HISTORIC PRESERVATION BOARD STAFF REPORT

160 Marine Way

Meeting	File No.	Application Type
August 5, 2026	HP-417-2026	Certificate of Appropriateness & Waiver

The item before the Board for consideration of a Certificate of Appropriateness (HP-417-2026) and Waiver in association with exterior modifications to an existing contributing structure and a 3rd story addition to the existing, contributing, single-family residence, located at **160 Marine Way, Marina Historic District**.

A3.01 SCALE : 1/4" = 1'-0" (FOR REFERENCE ONLY)

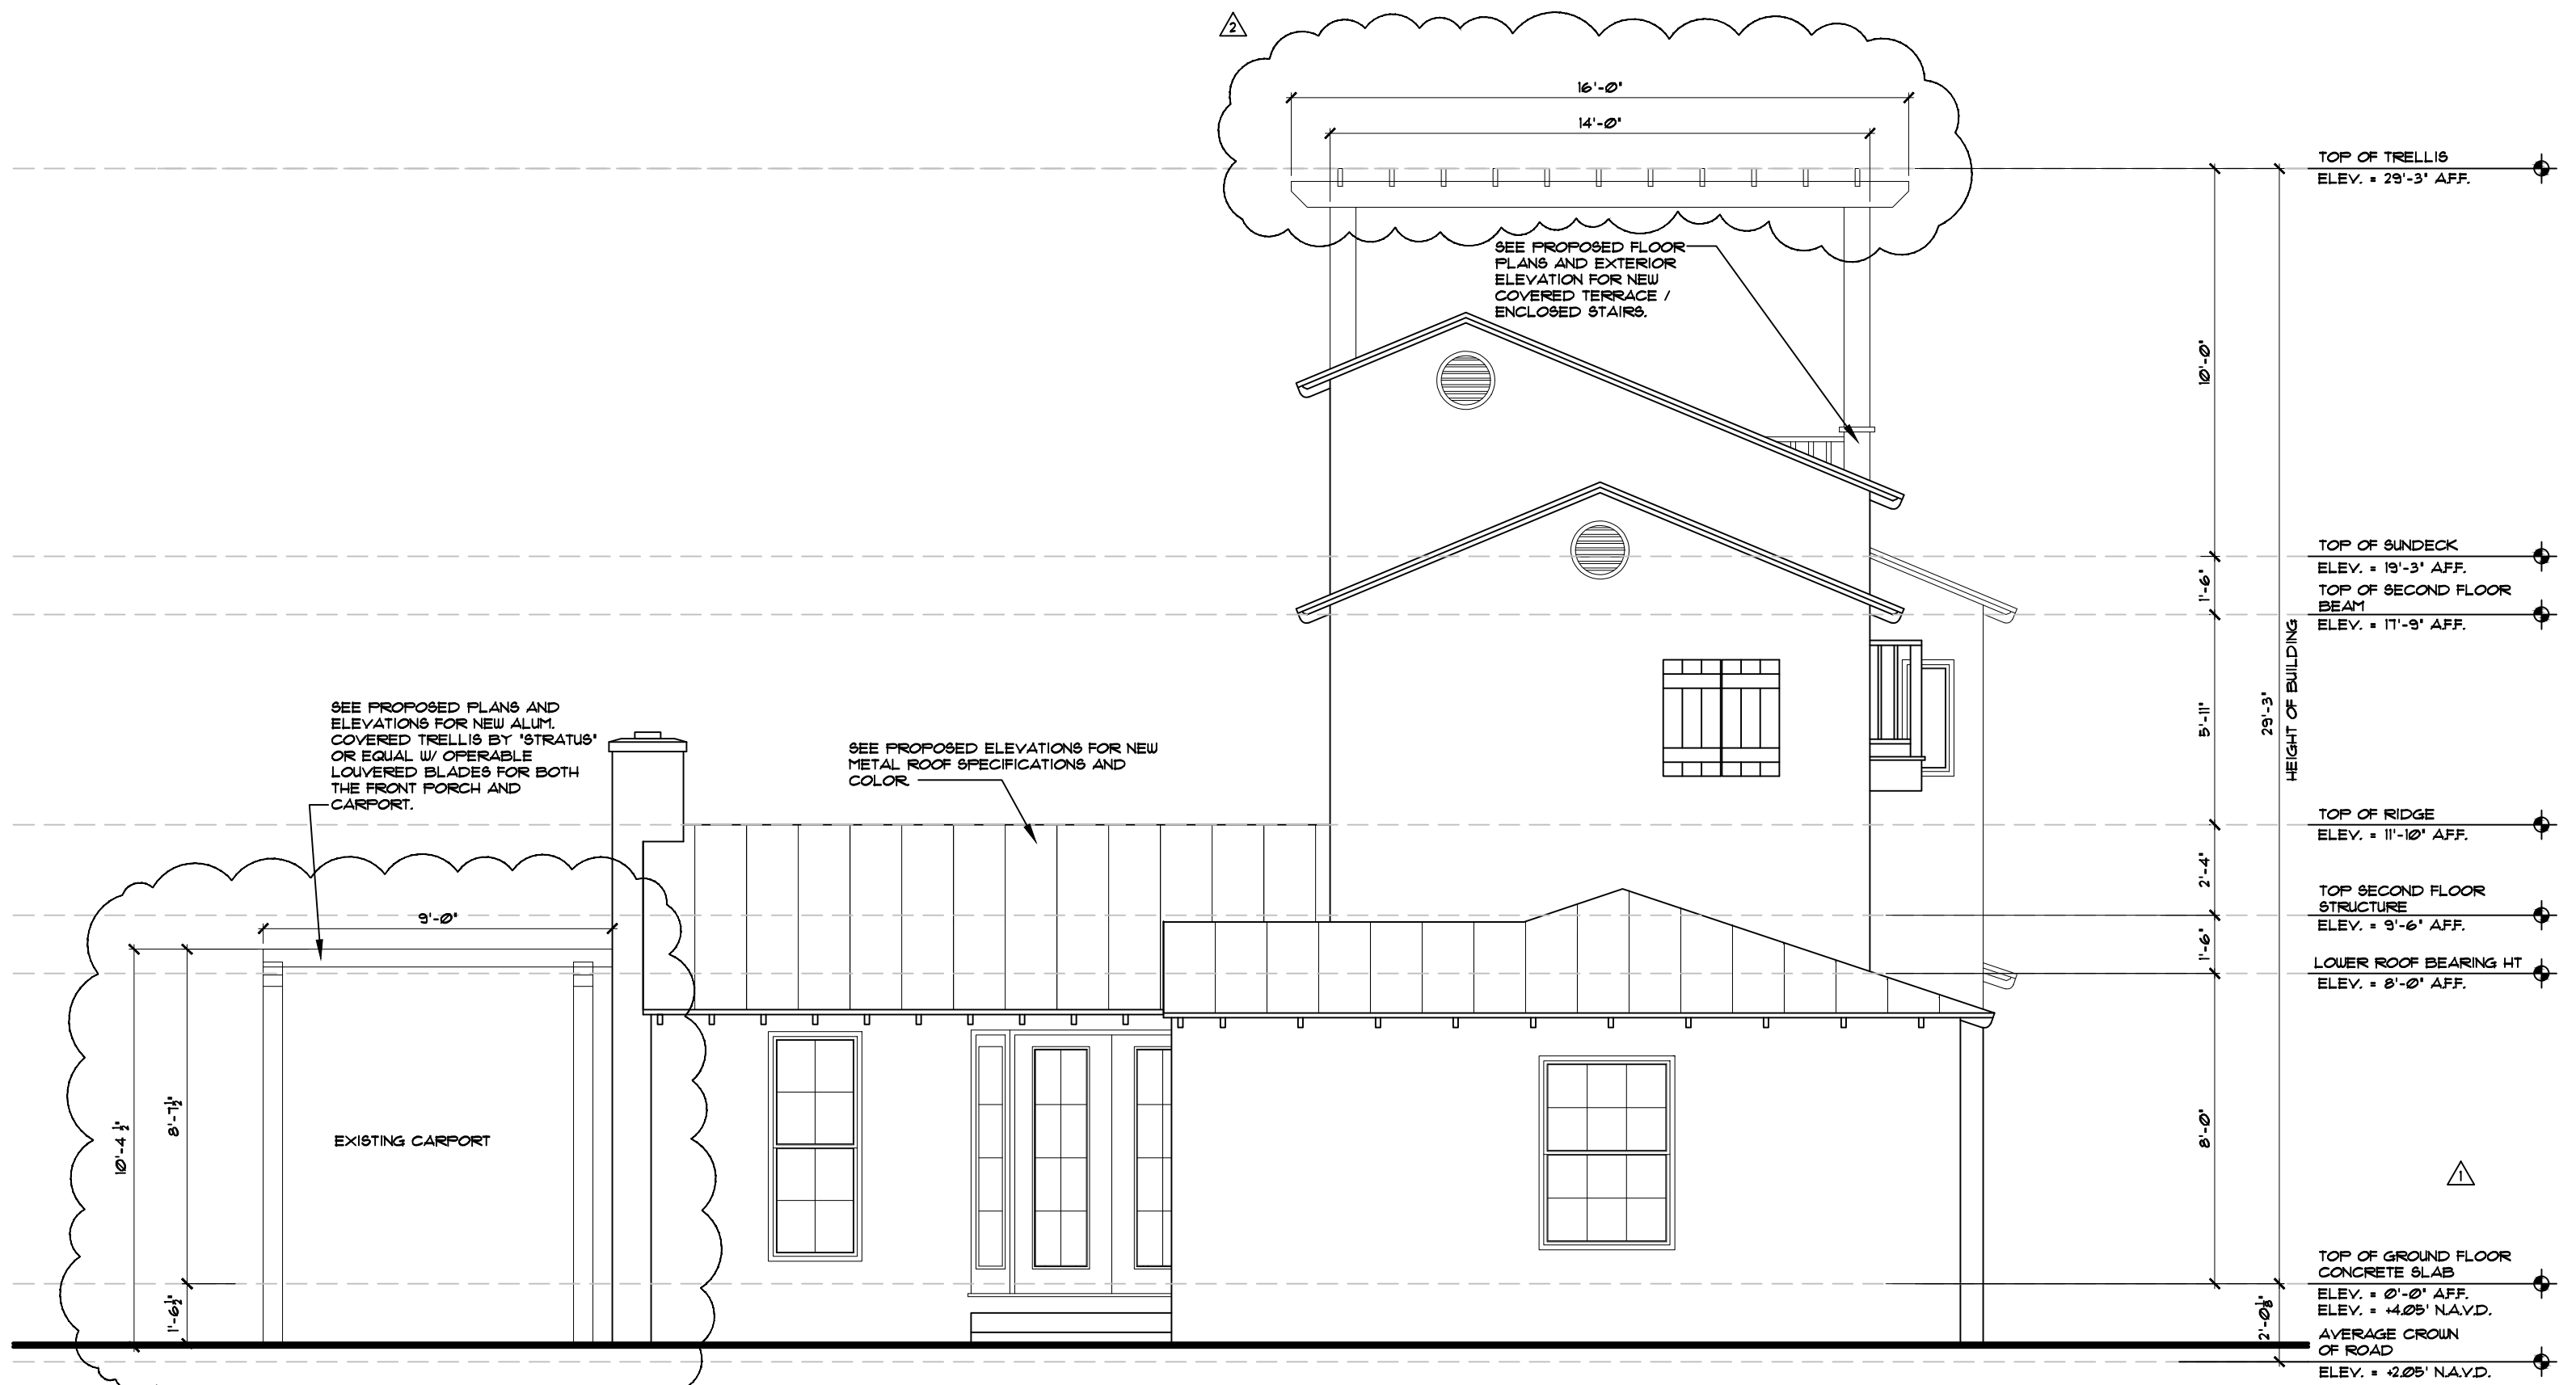
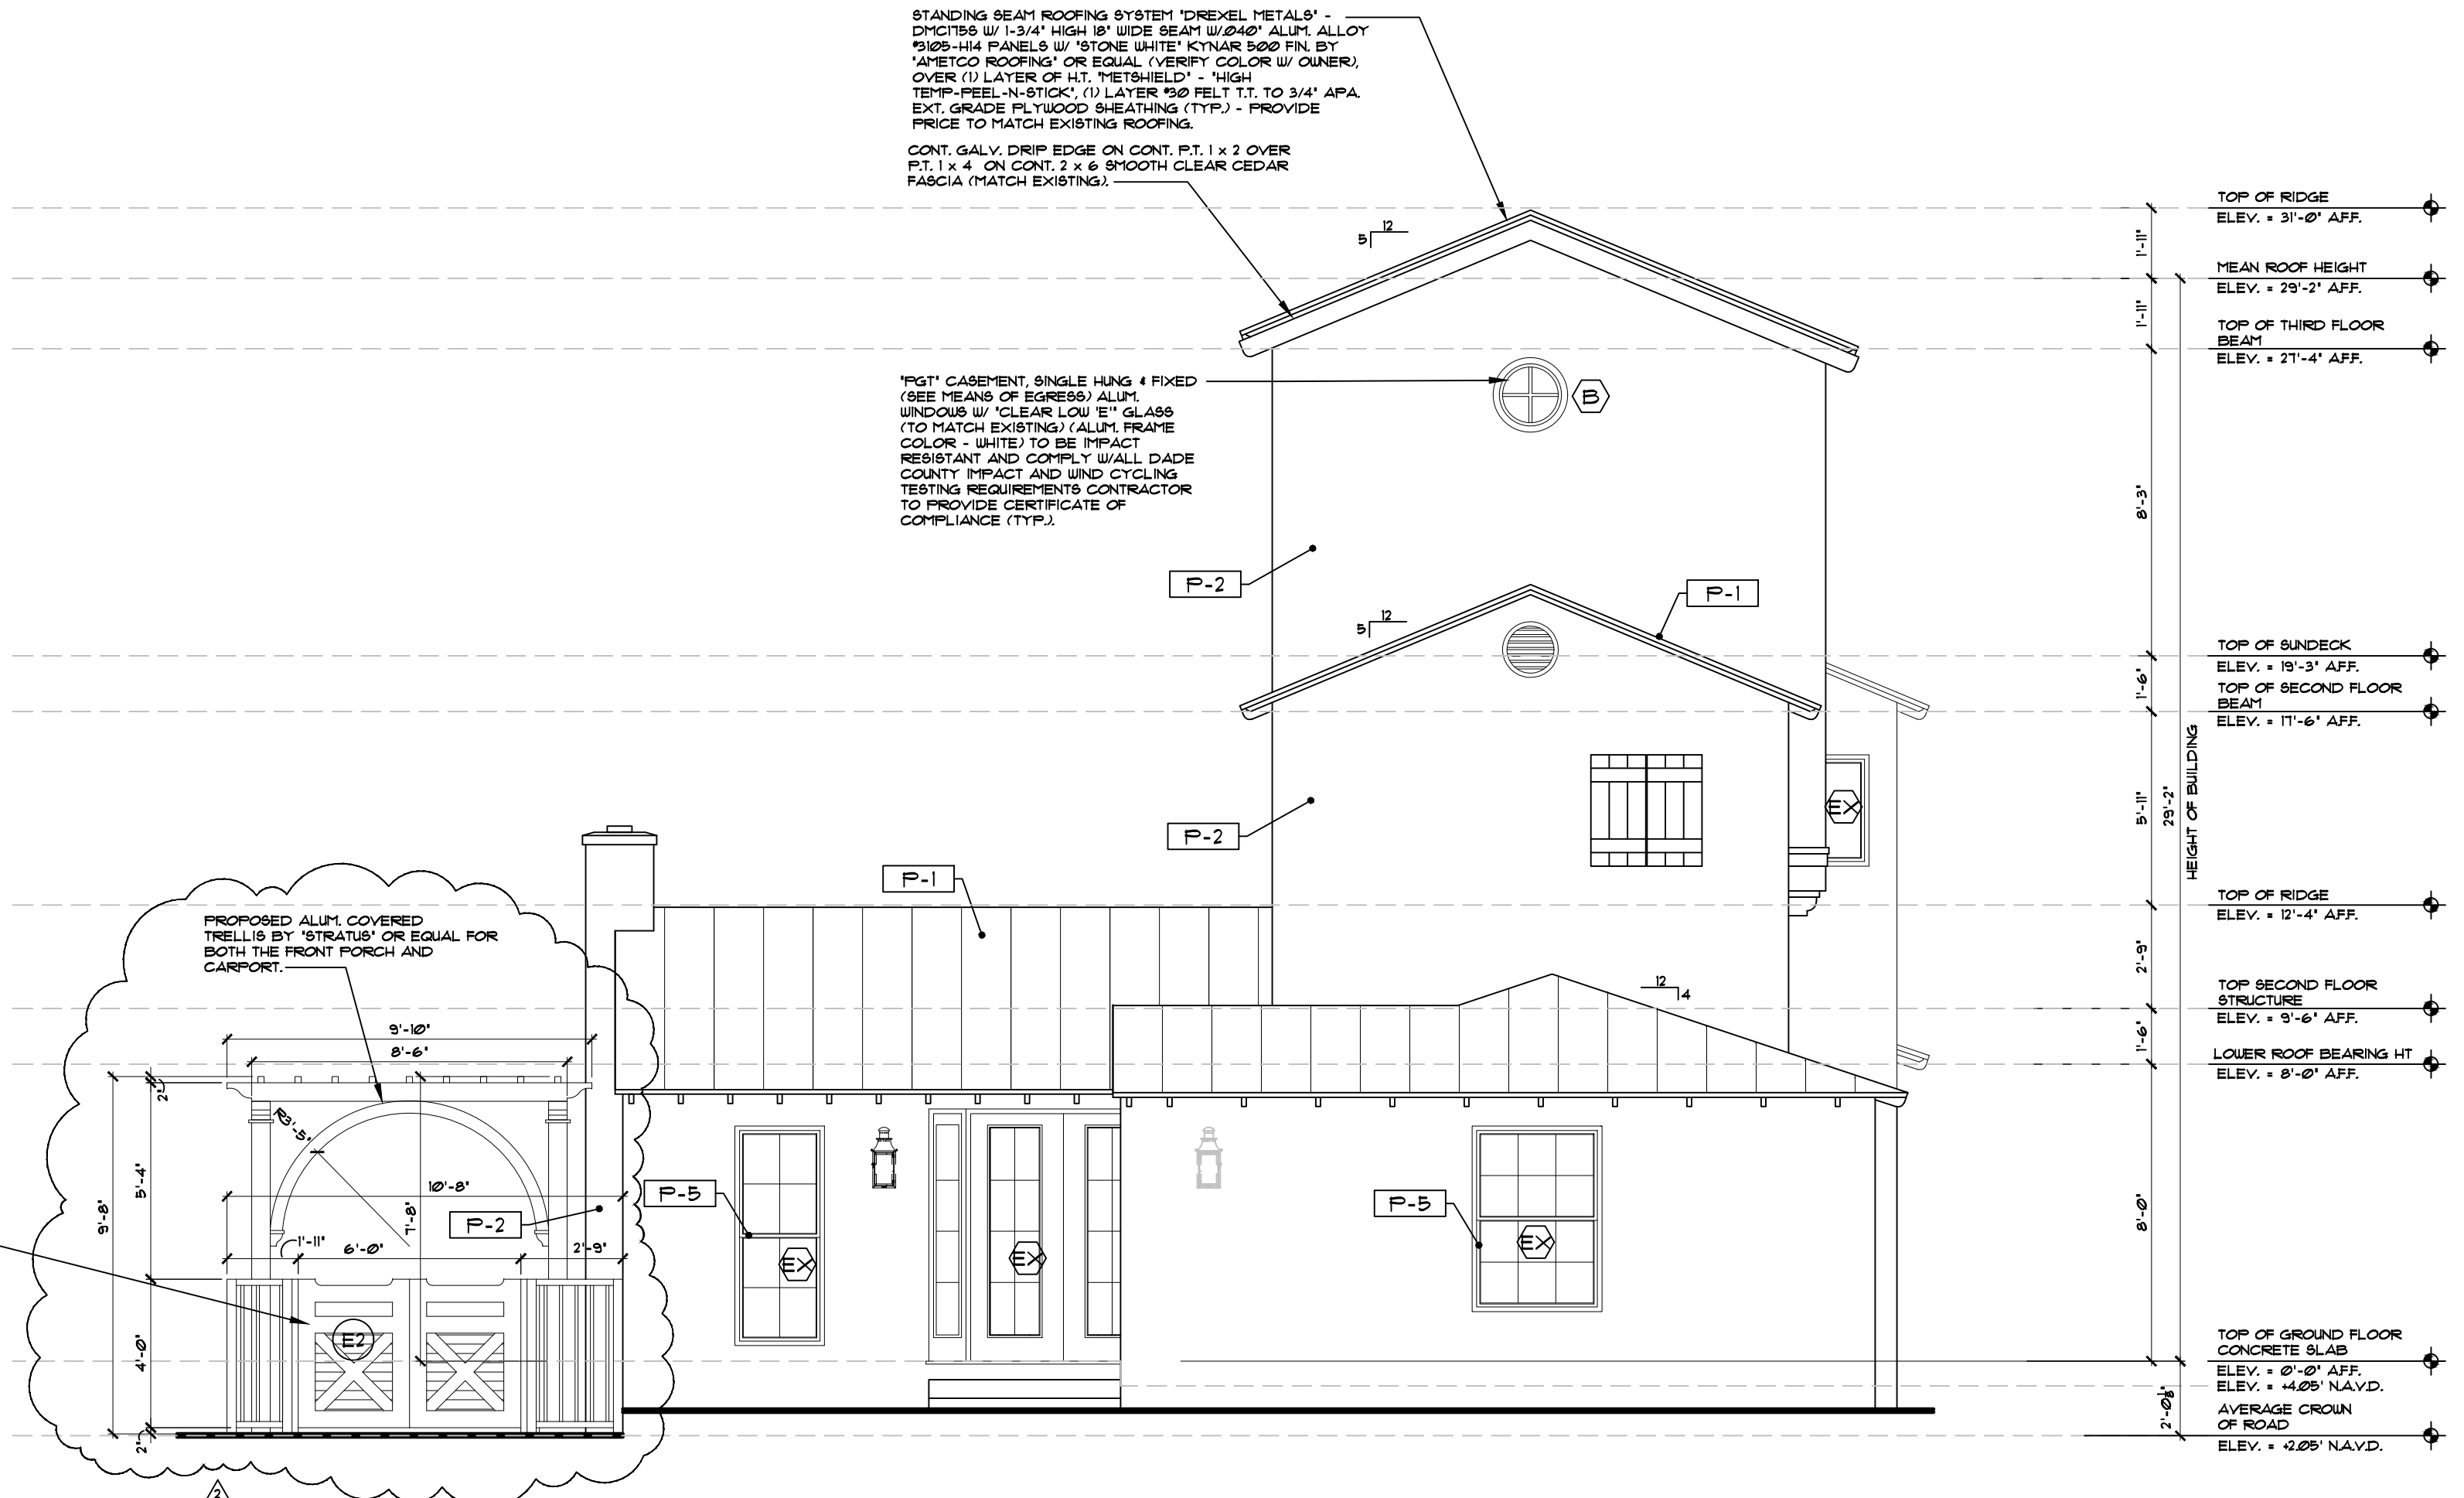
With regard to **Relationship of Materials, Texture, and Color and Roof**, the subject request includes the replacement of the existing wood trellises with aluminum, stucco exterior on the third-floor, aluminum framed windows & shutters, and replacement of the existing, 5-V crimp, mill finish, metal roof with a white standing seam metal roof. The addition of an eyebrow feature on the two double doors on the north elevation will also match the standing seam metal roof in “Drexel Metals” Stone White/Kynar 500 Fin.

The use of standing seam and 5-V crimp metal roofs within historic districts are required to be reviewed by the board and are on a case-by-case basis, to ensure visual compatibility with other structures and the districts as a whole. It is noted however, that aluminum shingle roofing has been deemed compatible for historic structures within the districts and can be approved administratively. While the board has approved metal roofs for historic structures, typically the color of the metal is “mill finish” or silver. This is because historically when metal roofs may have been utilized at the time of original construction, metal was only available in its natural color, not a painted finish. The most appropriate roof material is what was historically utilized, in this case this originally home had a shingle roof. However, the board

previously approved the use of a 5-V crimp metal roof for this structure – in a mill finish. The use of metal roofing has increased, given the city's location within a hurricane prone area and many owners have requested the use of metal roofs to aid in reducing insurance premiums and improve a structure's resiliency to storms.
